NO. 25188.03

STERLING RANCH ROAD & BRIARGATE PARKWAY STREET PLANS	H-SCALE	N/A	No.	REVISION	BY	DATE
	V-SCALE	N/A				
	DATE	2/10/22				
	DESIGNED BY					
NOTES & DETAILS	DRAWN BY					
	CRB					
	CHECKED BY					
SHEET	2	OF	32			
JOB NO.		25188.03

STERLING RANCH ROAD &
BRIARGATE PARKWAY STREET
PLANS
TYPICAL SECTIONS

STERLING RANCH ROAD

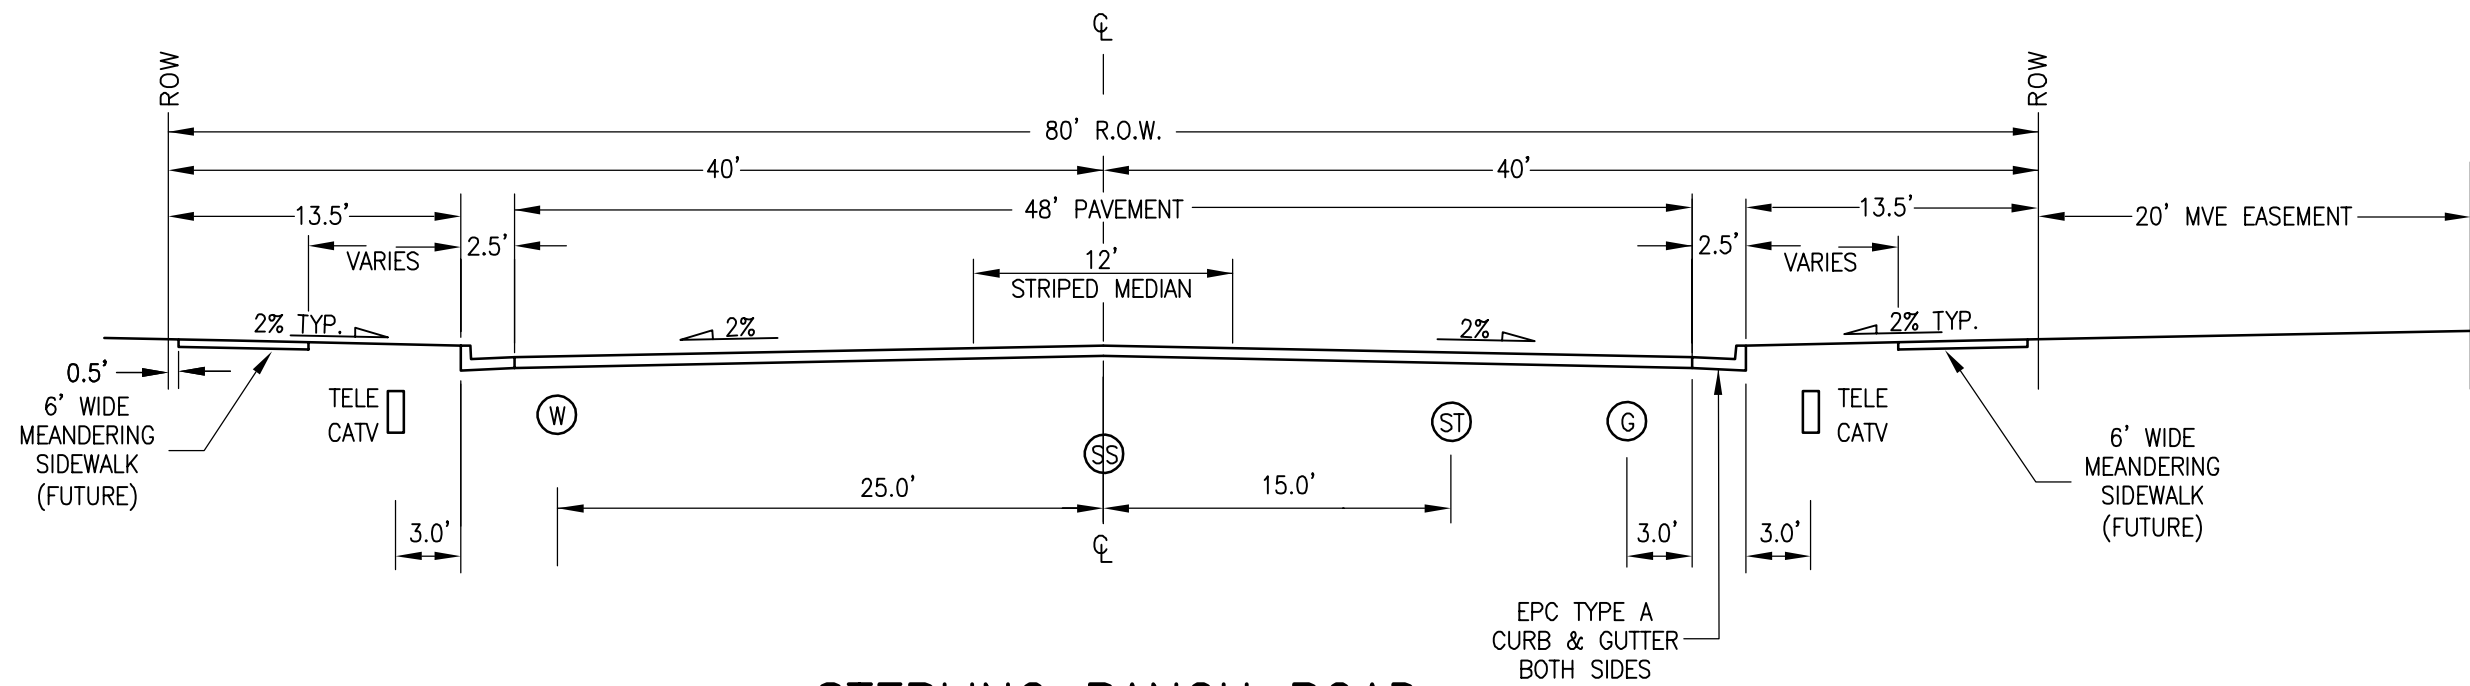
Per ECM Non-residential collector has 5' sidewalk. Please update

BRIARGATE PARKWAY – TYPICAL SECTION

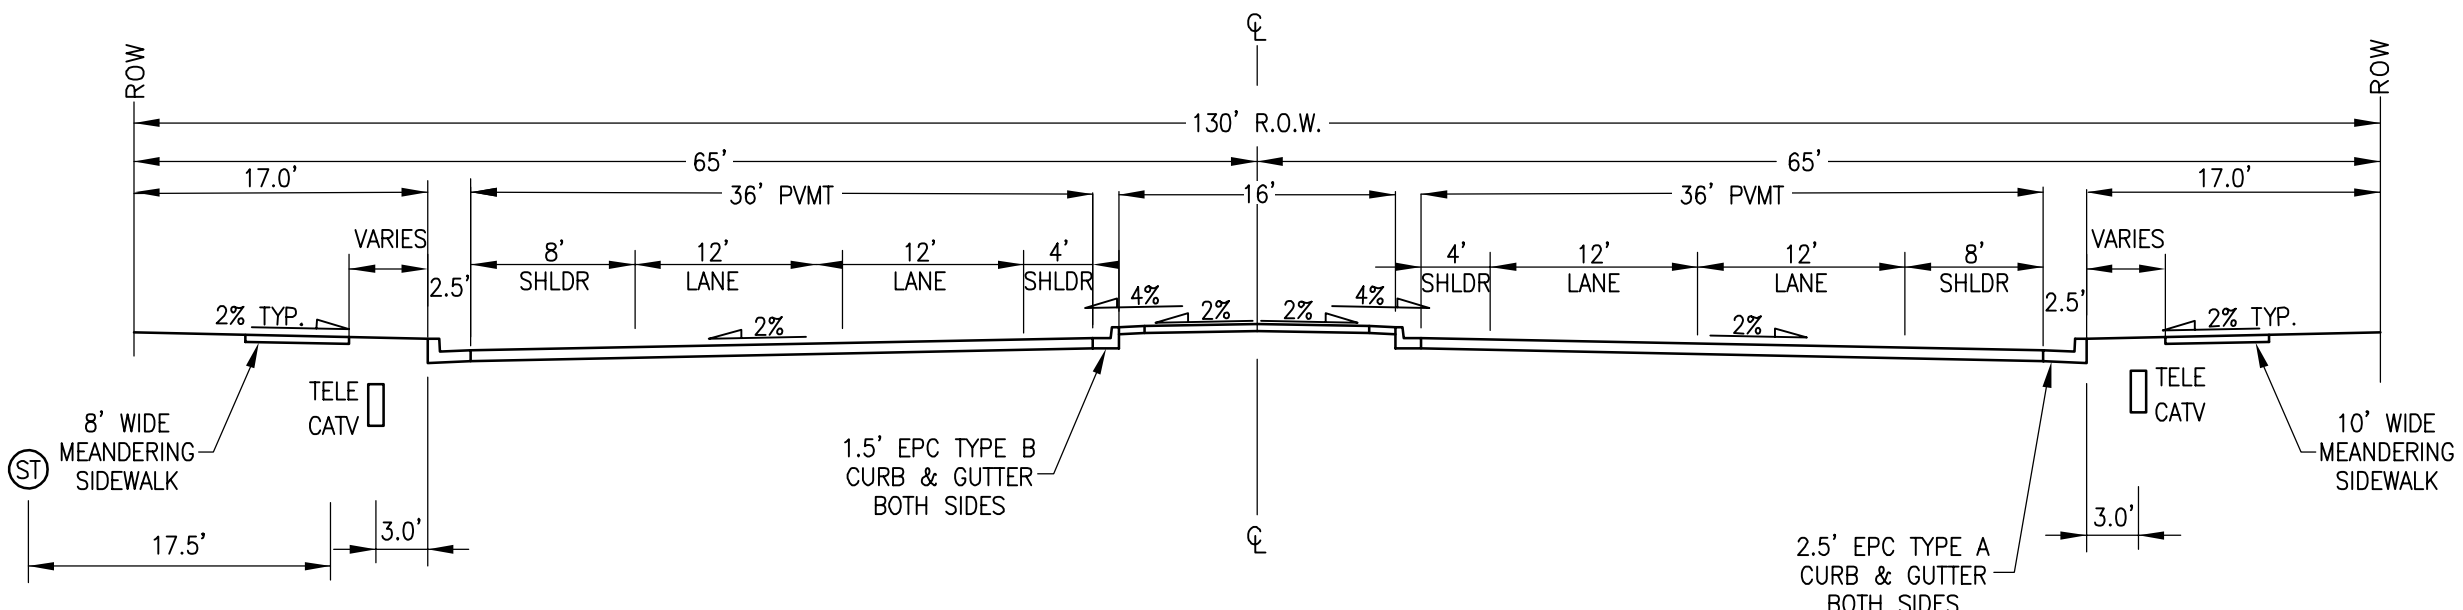
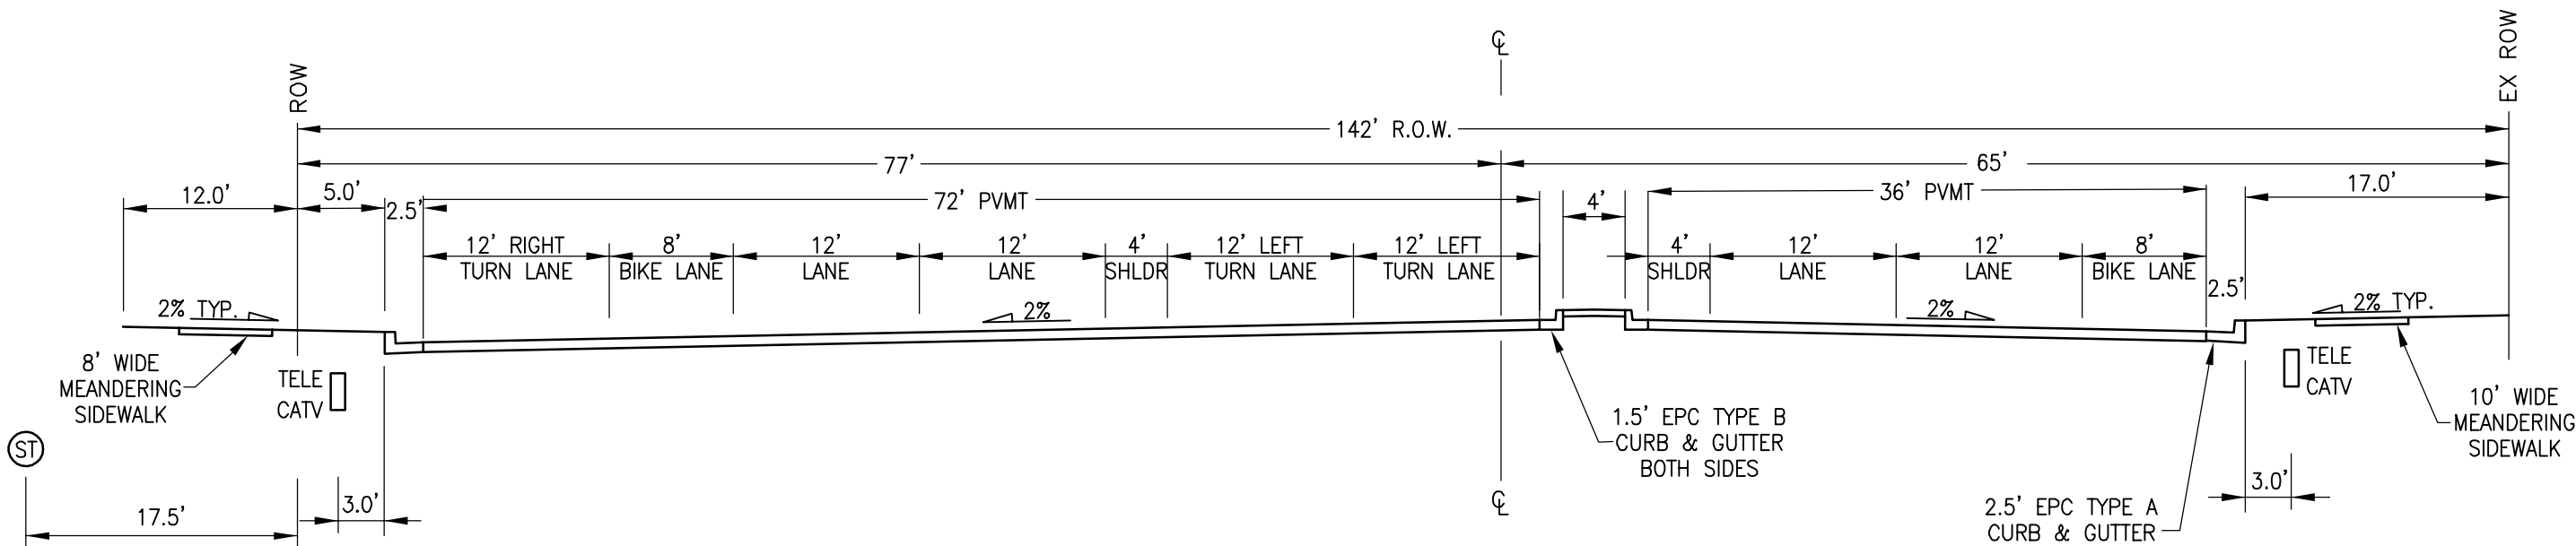
Per corridor plan North side of Briargate has 12' bike trail and south side has 6' sidewalk. Please revise sections and plan sheets accordingly.

VOLLMER & BRIARGATE SE PROFILE
STA 10+00.00 TO 10+93.27

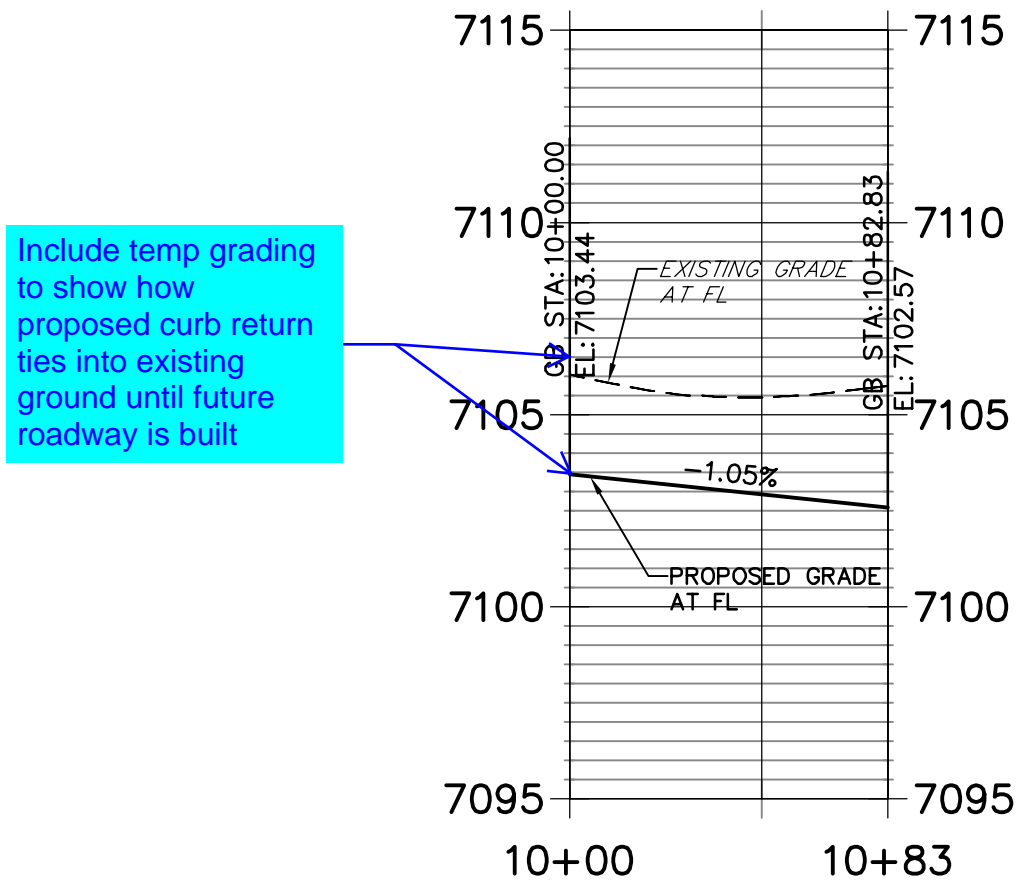
Include temp grading to show how proposed curb return ties into existing ground until future roadway is built

Include temp grading to show how proposed curb return ties into existing ground until future roadway is built

Grading should be matching with existing roadway

Grading should be matching with existing roadway

STERLING & ROAD X NW PROFILE
STA 10+00.00 TO 10+60.00

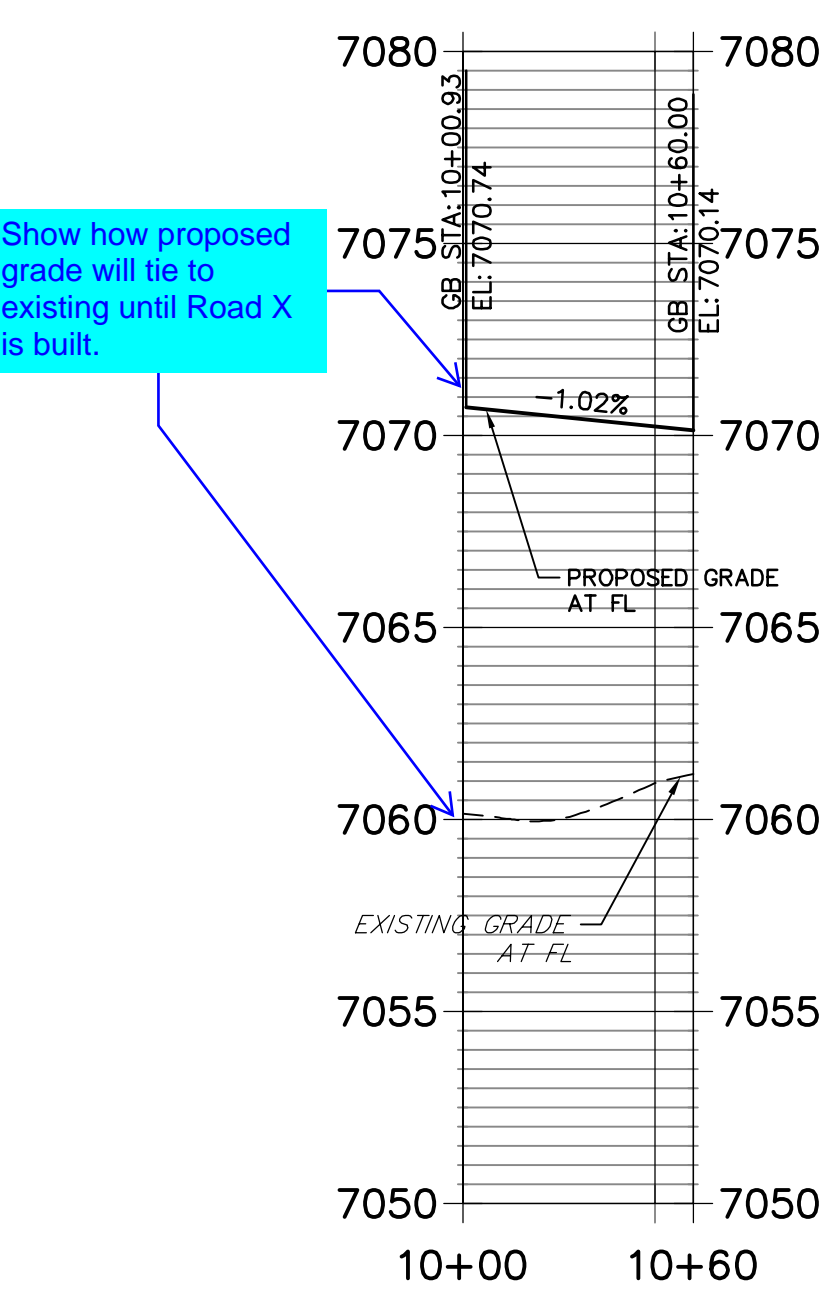
Show how proposed grade will tie to existing until Road X is built.

Show how proposed grade will tie to existing until Road X is built.

Show how proposed grade will tie to existing until Road X is built.

BRIARGATE PARKWAY
STA 10+00 TO STA 19+50

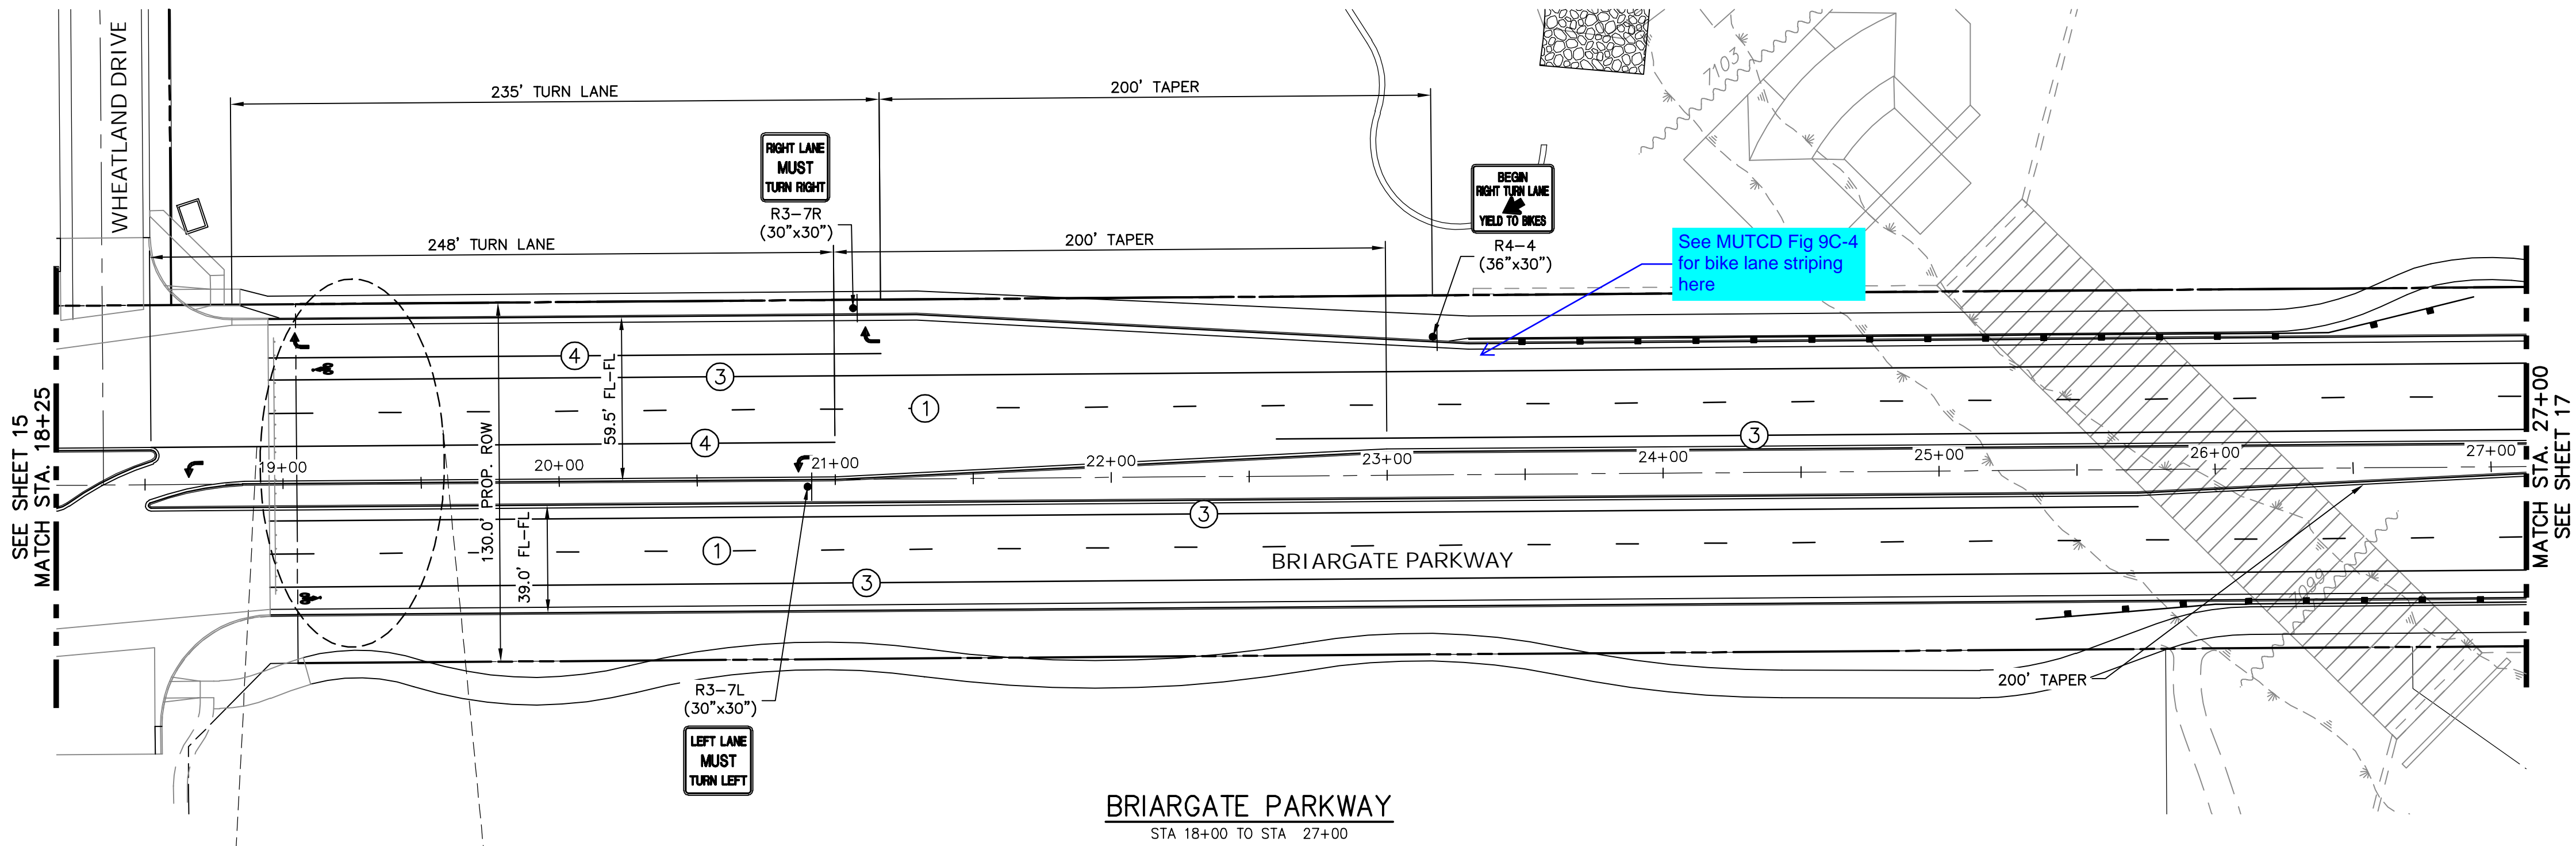
Add crosswalks, bicyclist and turn arrows to table & label in plan

Add crosswalks, bicyclist and turn arrows to table & label in plan
